AMENDMENTS TO THE DRAWINGS

- REMARKS / ARGUMENTS -

FIG. 1

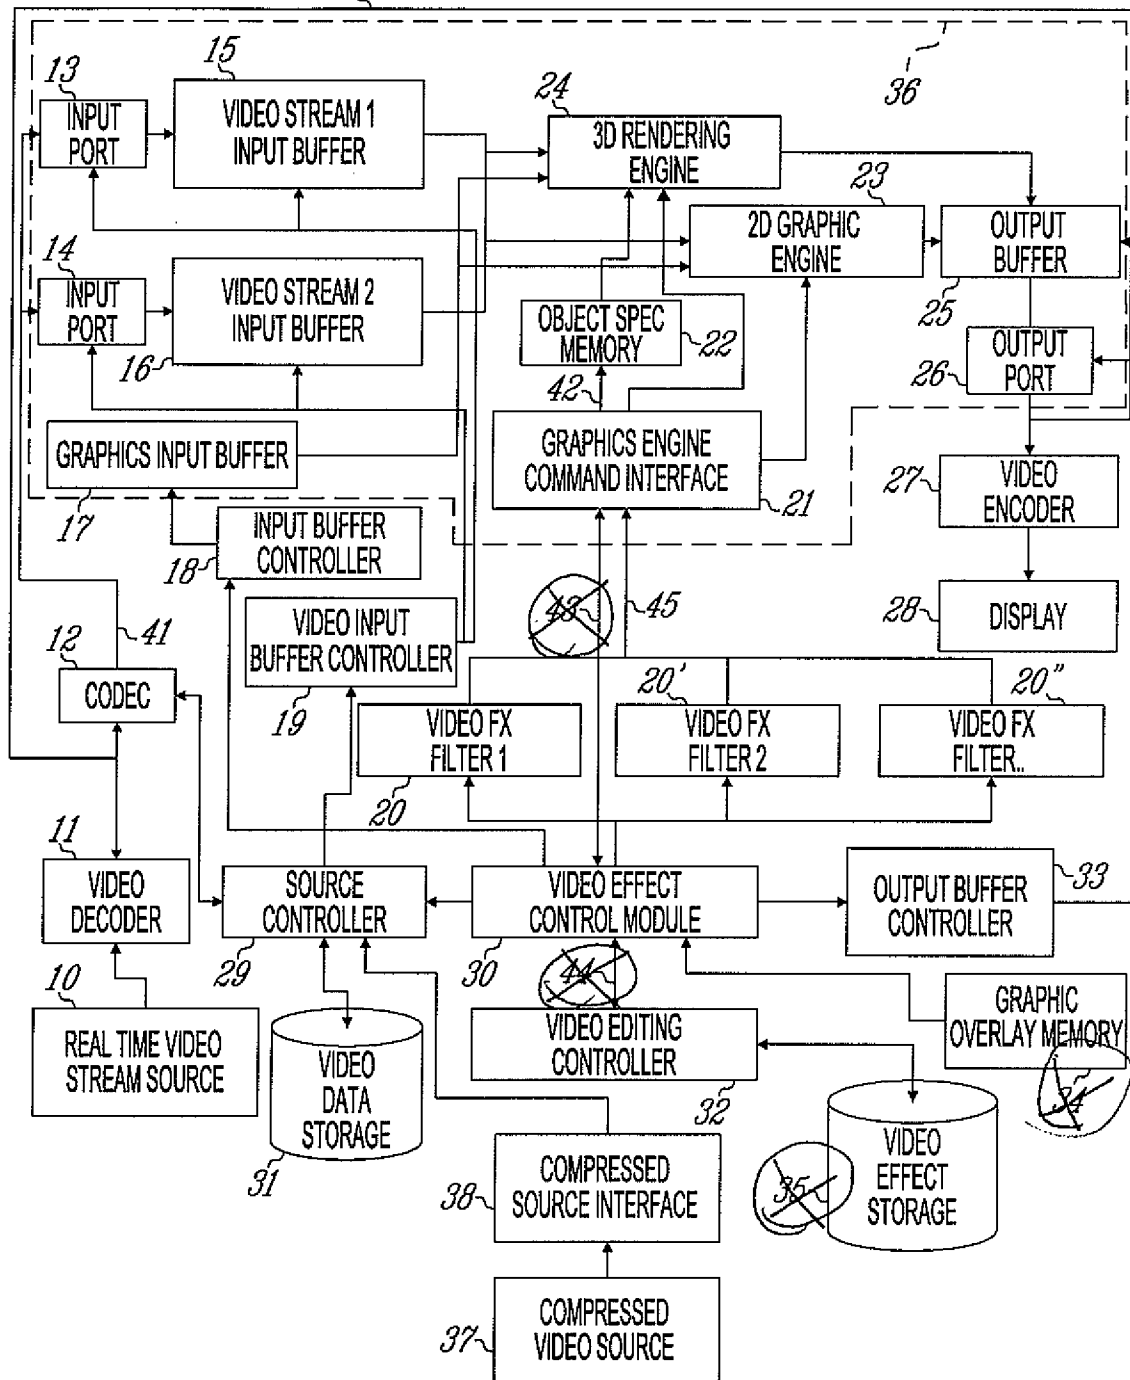
Reference numerals 34, 35, 43 and 44 on Figure 1 and reference numeral 90 on Figure 6 are deleted from the drawings as shown on the attached Marked-up version of the drawings and the attached replacement sheets.

The contents of the components and of the data signal connections between components to which these numerals were attached remain intact with the name of the components (in the blocks) being understood by one skilled in the art to represent the contents of the components. One skilled in the art will understand, from the disclosure as filed, what the contents of the components are and what data is between communicated via the data signal connections, without requiring use of these reference numerals.
